January 20, 1983

SBN- 427
T. F. B7.1.2

Subject: Open Item Responses

FIGURE 1

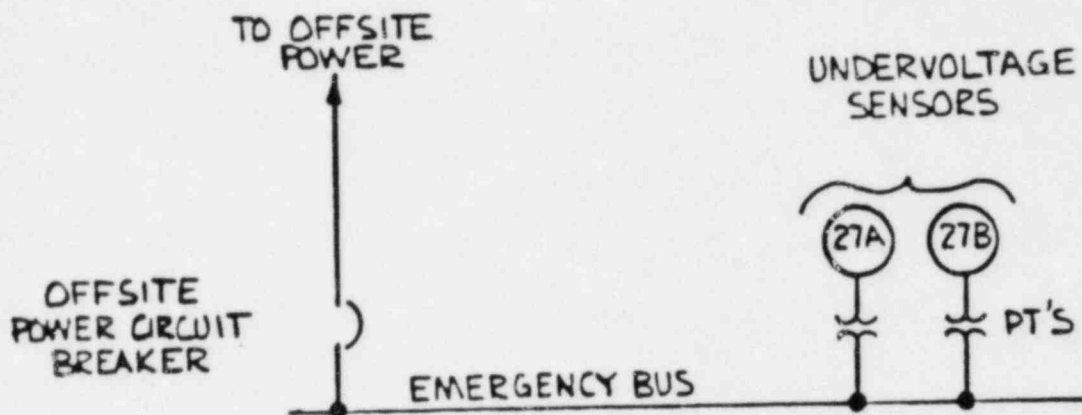
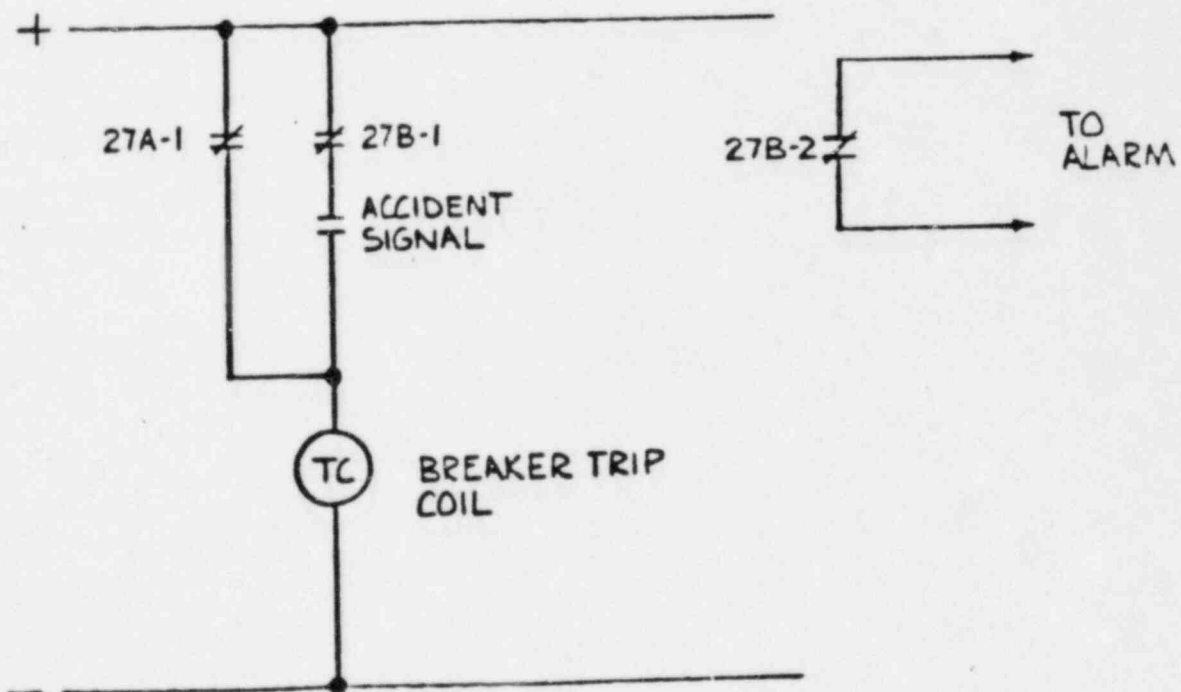
The circuit breaker connecting offsite power to the emergency bus is shown in Figure 1. The first level undervoltage relay is shown as device 27A. The second level undervoltage relay is shown as device 27B. Both relays sense voltage on the emergency bus.

With Alternative 1, a grid degradation experienced without an accident signal will only cause an alarm. Established plant procedures require the operator to take specific steps to assess the magnitude and expected duration of the grid degradation. If he is not assured that the disturbance is transitory, and that recovery is imminent, he may choose to manually trip the offsite power circuit breakers after ensuring that a further deterioration of safety will not result from his proposed action.

Of these four methods, we believe Alternative 1 is the most desirable scheme for our facilities. Additionally, the low probability disadvantages of Alternative 1 are outweighed by the advantages. We, therefore, propose to adopt Alternative 1 for mitigating the effects of a grid degradation. The sensors, and circuit to be utilized will be as detailed in Figure 1, and as described in the text above.

FIGURE 2

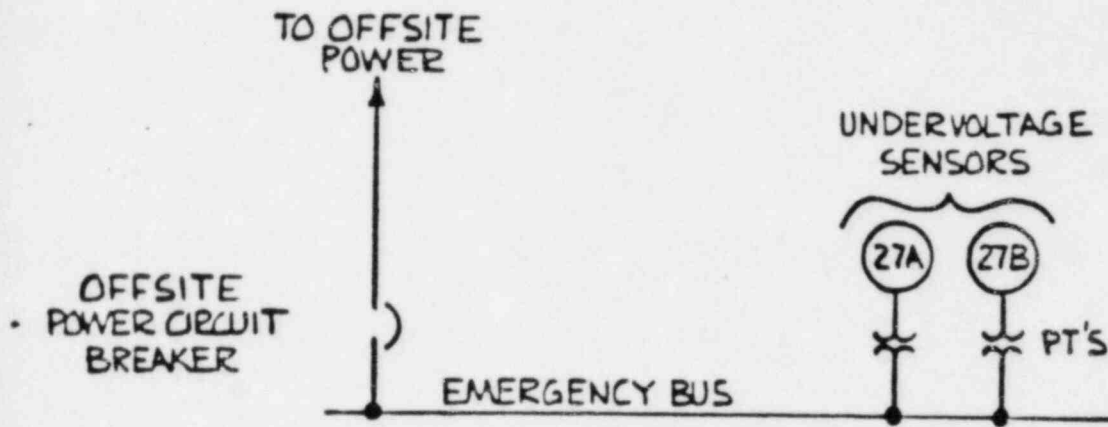
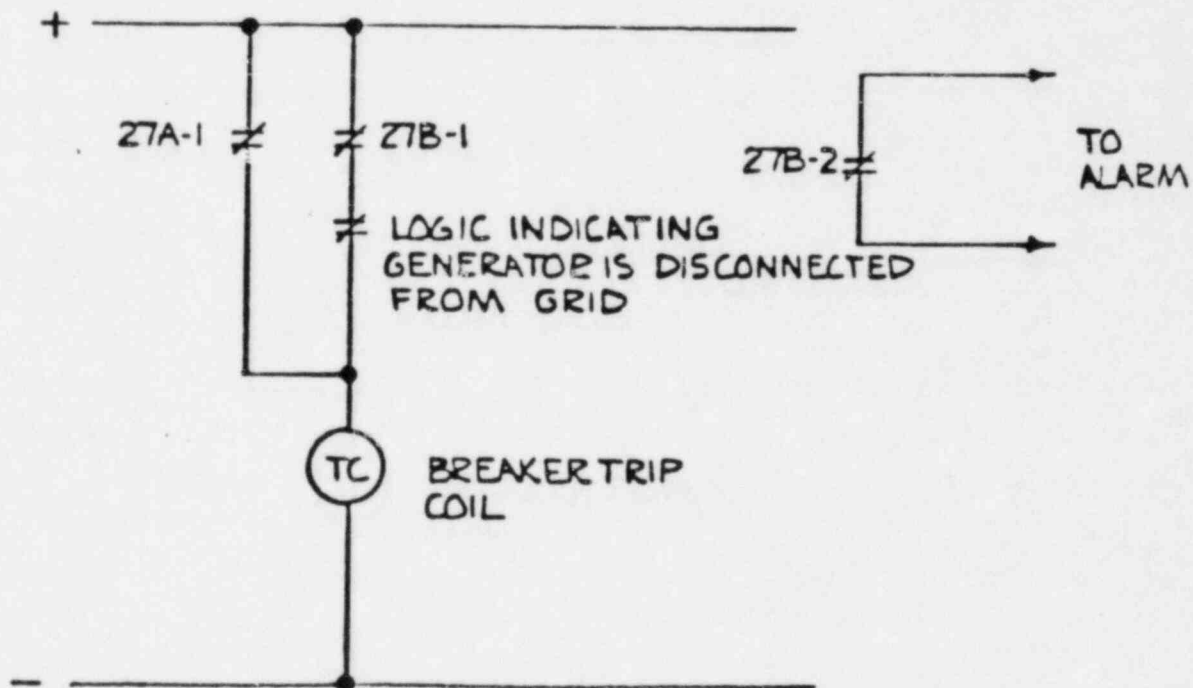
The circuit breaker connecting offsite power to the emergency bus is shown in Figure 2. The first level undervoltage relay is shown as device 27A. The second level undervoltage relay is shown as device 27B. Both relays sense voltage on the emergency bus.

With Alternative 2, a grid degradation experienced with the generator connected to the grid will only cause an alarm. Established plant procedures require the operator to take specific steps to assess the magnitude and expected duration of the grid degradation. If he is not assured that the disturbance is transitory, and that recovery is imminent, he may choose to manually trip the offsite power circuit breakers after ensuring that a further deterioration of safety will not result from his proposed action.
